**New Albany Architectural Review Board**  
Meeting Minutes, December 11, 2023 - Approved

**ARB-106-2023 Certificate of Appropriateness**

Certificate of Appropriateness to construct six new townhomes along Richmond Square located generally north of Main Street, south of McDonald Lane, and west of Keswick Drive (PID: 222-000043).

**Architectural Review Board Staff Report  
December 11, 2023 Meeting**

**2.55 Building Frontage Standards:**

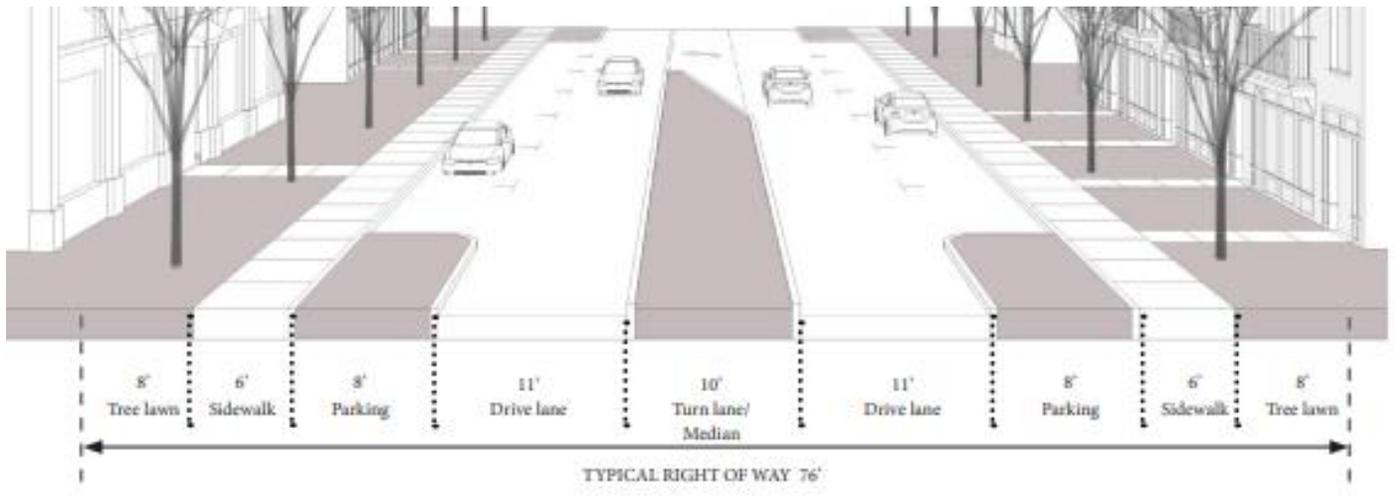
- Per 2.55.1, at least one functioning entrance to the townhome shall be provided from the street or side yard. The applicant meets this standard as there is a functioning entrance along all street yards. Each entrance includes a covered stoop.
- Per 2.55.2, a building frontage in accordance with section 3.2 shall be incorporated at the street or side yard entrance. Each functioning entrance has its own size and setback requirements. In this case, the applicant proposes covered stoops, which is permitted. The covered stoops must adhere to the following standards:

<p><b>3.10 Covered Stoop Standards</b></p> <p>3.10.1 The following standards shall be used for covered stoops:</p> <p style="padding-left: 40px;"><i>Minimum width (a): 5'</i></p> <p style="padding-left: 40px;"><i>Minimum depth (b): 4'</i></p> <p style="padding-left: 40px;"><i>Maximum landing height (c): 42"</i></p> <p style="padding-left: 40px;"><i>Minimum clearance (d): 8'</i></p> <p>3.10.2 Covered stoops and steps may encroach up to 2' within the right-of-way, subject to the approval of the City Manager or designee. A minimum pedestrian clear zone of 5' must be maintained.</p> <p>3.10.3 Stoop roof may be used as balcony space or enclosed to create habitable space.</p>	<p><b>Proposed</b></p> <p>Width: 6.5 feet width  Depth: 1.5 depth  Height: 28"  Clearance: 9.5 feet</p> <p><u>Staff recommends a condition of approval that the front stoop depth and height are revised to meet code requirements (condition #11).</u></p>

Richmond Square and Keswick Drive:

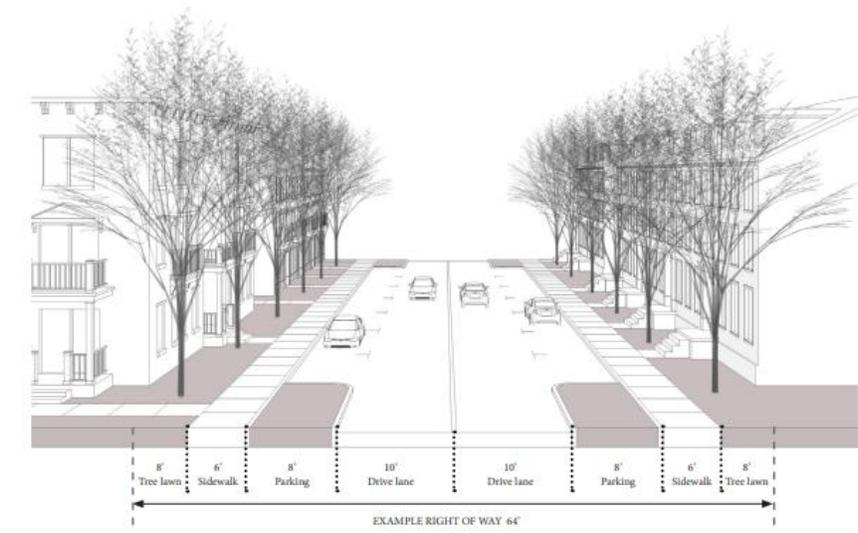
- Urban Center Code Section 5.1 identifies Richmond Square and Keswick Drive as a Village Avenue. The following standards apply:

<b>Standard</b>	<b>Minimum</b>	<b>Maximum</b>	<b>Proposed</b>
Tree Spacing	25'	25'	25' [proposed and meets code]
Tree Lawn	6'	8'	14' [proposed, <u>Staff recommends a condition of approval that the plans be updated to meet this code requirement (condition #10) by shifting the sidewalk closer to the street so there is an 8-foot-wide tree lawn.</u>
Sidewalk Width	6'	8'	5' [proposed] <u>Staff recommends a condition of approval the side is a minimum of 6 feet wide.</u>
Parking Width	8'	8'	No on-street parking is proposed in order to match the existing street typology established by the apartments and Keswick subdivision. Staff is supportive and recommends the tree lawn be 8 feet to accommodate the possibility of future on-street parking.
Drive Lane Width	9'	10'	13' [existing and approved by ARB via Keswick application]
Turn Lane Width	-	-	-
Total R.O.W	58'	64'	50 feet

10. The plans shall be updated to provide a 6'8-foot-wide tree lawn along Keswick Drive.
11. The plans shall be updated to clarify whether the covered stoops meet code.
